Item Name: Cable Assembly

DART SERVICE INSTRUCTION

TO AMEND IIN-D412-704 REV. C OR EARLIER

AND ICA-D412-704 REV. 4 OR EARLIER

Figure 5 - Detail L or Figure 25-4 - Detail L

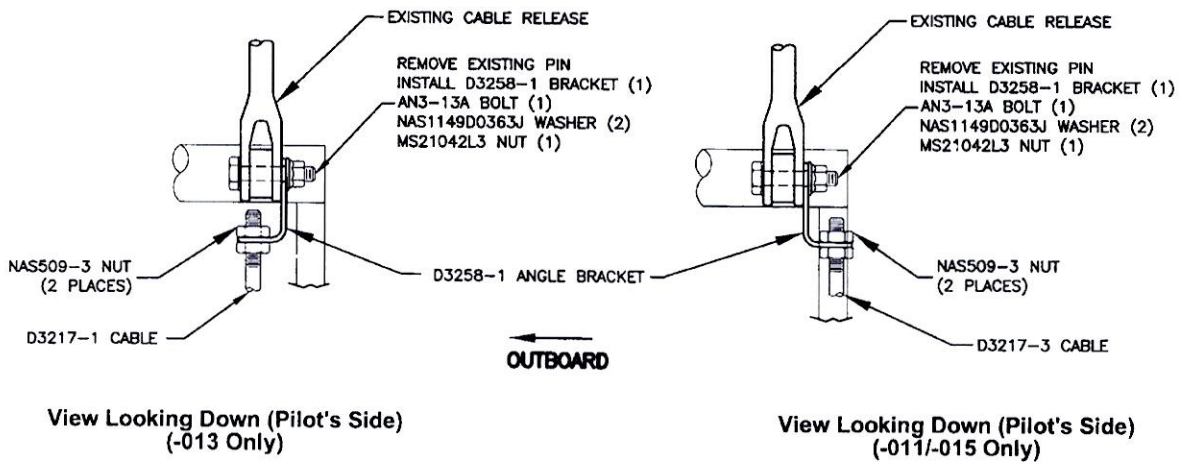
The purpose of this Dart Service Instruction is to correct part number error in Installations Instruction IIN-D412-704 Rev. C or earlier and Instructions for Continued Airworthiness ICA-D412-704 Rev. 4 or earlier. The AN3-13A bolt should be replaced with an AN3-10A bolt in Figure 5 - Detail L in IIN-D412-704 and Figure 25-4 Detail L in ICA-D412-704. See sheet 2.

FIGURES CORRECTION

Revise Detail L Figure 5 of IIN-D412-704 and Detail L Figure 25-4 of ICA-D412-704 as follows:

NOW

WAS
